**MODIFICATION REQUEST:
CASUARINA TOWN CENTRE
TWEED COAST ROAD, CASUARINA
06_0258 MOD 5**

Director-General's
Environmental Assessment Report
Section 75W of the
Environmental Planning and Assessment Act 1979

September 2013

Figure 5: Plan of proposed retaining wall and associated works (Source: Newton Denny Chapelle)

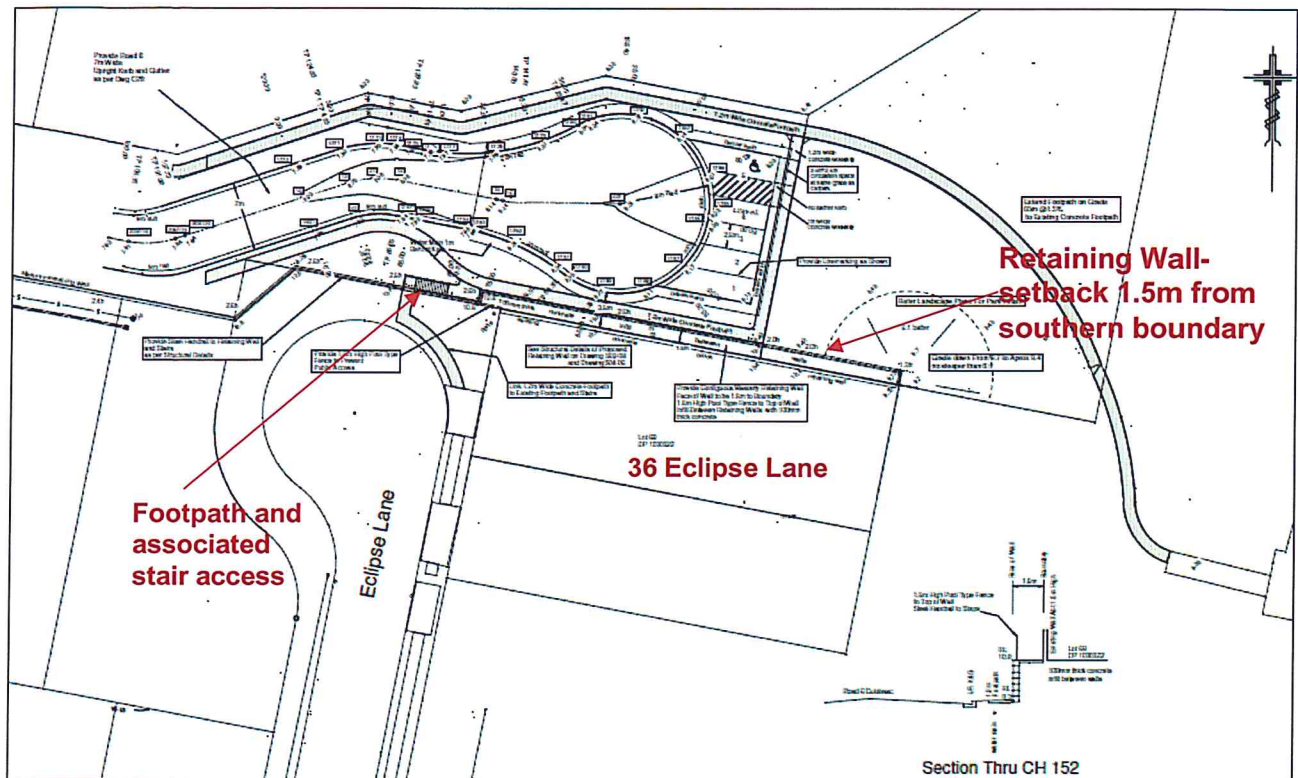
On 26 July 2013, Newton Denny Chappelle on behalf Clarence Property Corporation Pty Ltd (the proponent), submitted a S75W modification request to the Stage 1 Project Approval MP06_0258. The proposed modification relates to the location and design of the retaining wall adjacent to the cul-de-sac head of Road 6 (a new road), in the south-eastern corner of the site. The retaining wall is proposed to reconcile level changes between the site and the neighbouring properties directly to the south including, No. 36 Eclipse Lane and the turning head of Eclipse Lane. There is approximately a 2.5 metres difference (fall) between the natural ground level at the southern boundary and the design level of Road 6 - refer **Figure 5** below.

The application also includes minor changes to the footpath alignment and the access stairway adjacent to Eclipse Lane, as illustrated in **Figures 5** and **6** below.

e	The steps should be relocated to the western side of the courtyard to accommodate the majority of the pedestrian traffic.	The department concurs with these comments. The proponent has agreed to locate the stairs to western side of the cul-de-sac. A revised plan has been submitted to address this matter. Refer to further discussion in section 5.2 below.
f	The current proposal will require pedestrians to use the footpath and deteriorating footbridge in front of our property raising concerns regarding noise, safety and security.	The design of the pathway connecting to the footbridge to the east is consistent with the design shown on the Concept Approval and Project Approval drawings and does not form part of this modification application.
g	The retaining wall is not in keeping with the natural landscape of the Casuarina beachfront.	Refer to comments at Point 3d above.
h	There does not need to be any retaining wall in front of the property. There is plenty of fill to provide for natural contouring across the site.	The levels proposed to be constructed are generally consistent with the Project Approval. For this reason, it is considered inappropriate that the civil works be redesigned to provide for the graduation of the land contours.

Figure 5 above indicates that a new stair is to be constructed at the northern end of Eclipse Lane to provide public access to the new levels established relative to Road 6. These stairs are proposed to link into the pathway network which provides access to the public parking at the eastern end of Road 6 and further beyond to the east, to the beach.

Concern has been raised in public submissions in relation to the location of the stair and the potential for its use to impact on the amenity and safety of neighbouring properties i.e. given its proximity to these properties. The department concurs with the concerns raised in submissions and considers that these impacts could be mitigated by relocating the stair further to the west of its current locations. Following further consultation with the department, the proponent has agreed to relocate the stair to the western side of Eclipse Lane as illustrated in **Figure 9**.

Council has been consulted in relation to this design amendment and has raised no objection. On this basis, the department considers the amended design to be acceptable.

Figure 6: Typical section through retaining wall (Source: Newton Denny Chapelle)

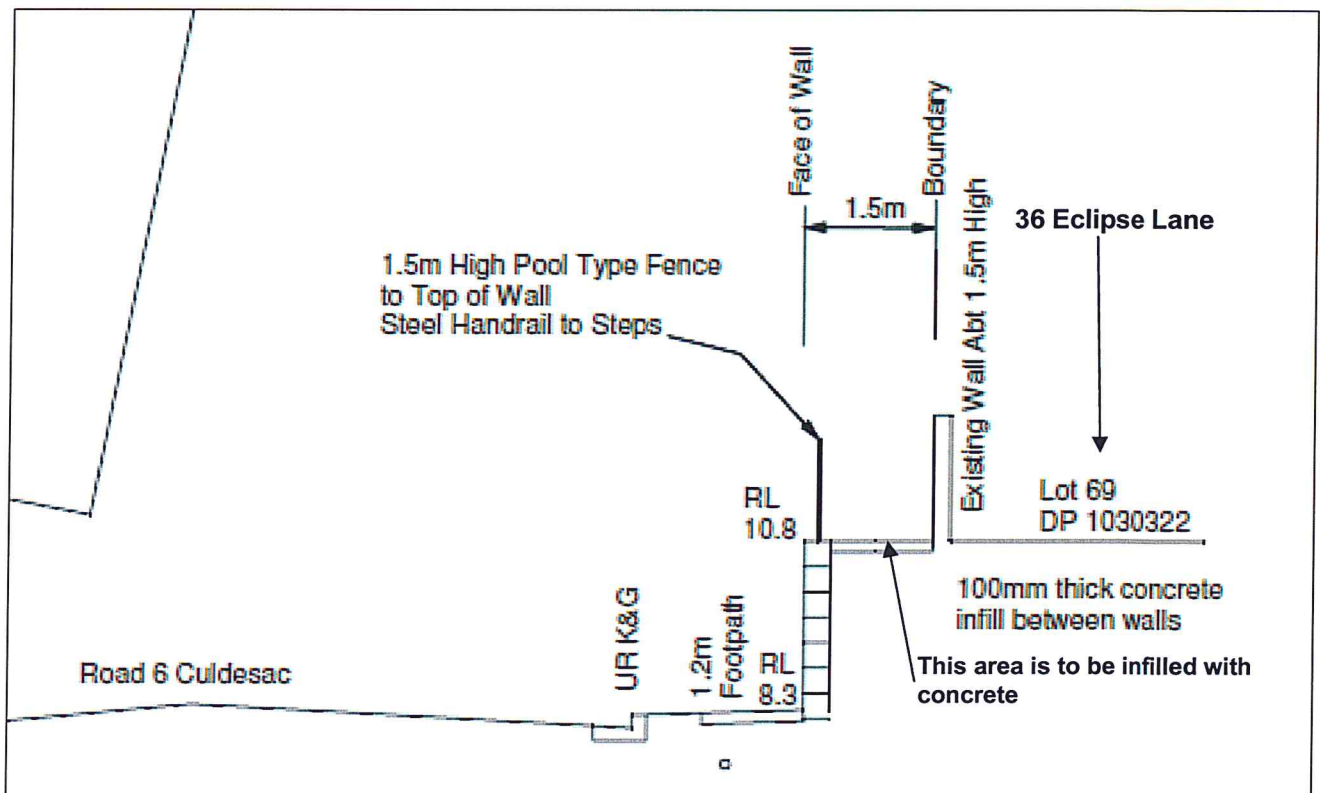
The retaining wall is proposed to be setback a minimum of 1.5 metres from the southern boundary of the site, where it adjoining 36 Eclipse Lane. A 1.5 metre high pool type fence is proposed to be constructed above the retaining wall- refer **Figure 6** below. Further to the west, the retaining wall is proposed to be located on the site boundary where the land is contiguous with the cul-de-sac head of Eclipse Lane.

As detailed in section 4.2, the neighbouring land owner at 36 Eclipse Lane has raised concerns in relation to the design of the retaining wall, including the location of the wall. The modification application seeks approval to locate the retaining wall 1.5 metres off the southern boundary of the site and furthermore, to install a pool type fence on the northern edge, for safety reasons. The retaining wall is proposed to be surfaced in a shotcrete finish. As illustrated in **Figures 5 and 6**, the area between the retaining wall and the boundary fence of No.36 Eclipse Lane is to be infilled with concrete.

Council has raised no objection to the proposed design. As Road 6 and the surrounding land to the southern boundary will be dedicated to Council, Council has advised that the infill area between the boundary wall and the new fence is not to be landscaped in order to minimise ongoing maintenance requirements and furthermore, that the concrete infill is to be provided with a grade of 1%, falling towards the face of the retaining wall. Council has also advised that the area is to be provided with a lockable gate, to allow future access for maintenance.

Subject to the final construction details complying with the requirements of Council, the department raises no objection to the design of the retaining wall. The design requirements of Council are recommended in new condition B2(5).

- **New Condition B2(5)** – as detailed in Section 5.2, Council has recommended that the final design for the retaining wall incorporate a locked gate and furthermore, that the concrete infill be design with a grade of 1%. New Condition B2(5) is recommended to address these requirements.

Figure 7: extract from approved plan DA105 (MOD 2)

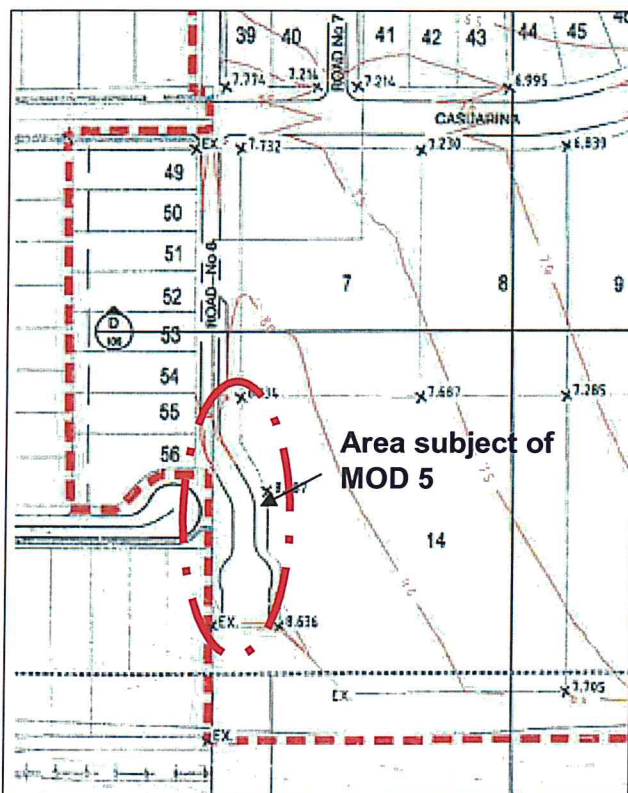
As detailed in Section 1.2 above, MP 06_0258 MOD 2 included an amendment to the extent of approved cut and fill on the site. An extract of the approved plans, showing the levels relative to the south-east corner of the site are provided at **Figures 7** and **8** below. These plans illustrate that there would be cut relative to the southern boundary for the road construction to reconcile with the existing level of RL8.6 at the southern end of the cul-de-sac head of Road 6.

CC13/007 issued for the Stage 1A works (including the bulk earthworks), generally accords with the levels illustrated in **Figures 7** and **8**. Whilst insufficient details were shown on the application drawings accompanying MOD 2 to indicate that a retaining wall was required along the southern boundary of the site (the department notes that this was not identified on any plan), it is relevant and appropriate that an engineered solution be constructed to reconcile these new land levels with those existing at the boundary.

In this instance, the department is satisfied that the construction of the retaining wall is the most appropriate and practical solution without significantly altering the subdivision layout (as approved). The department is also satisfied that the proponent has given sufficient consideration to alternative options to reconcile the level changes and notes that Council has raised no objection to the proposal.
